ADA Curb Ramp New Construction Inspection Form (Parallel)

NW West Union

23885.56

NW Stewart LN

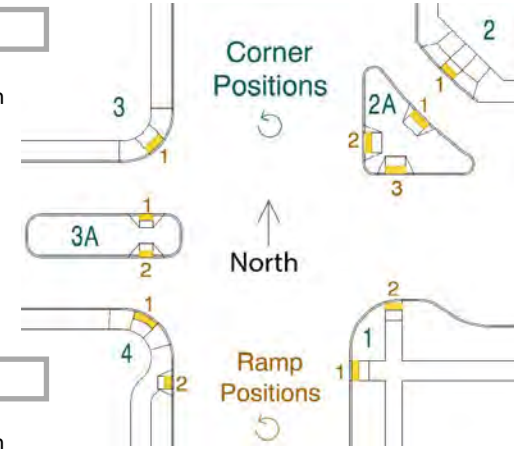
9.6 $\leq 8.3\%$ ☐ $> 8.3\%$ ☒

DWS IITD Fails turn space
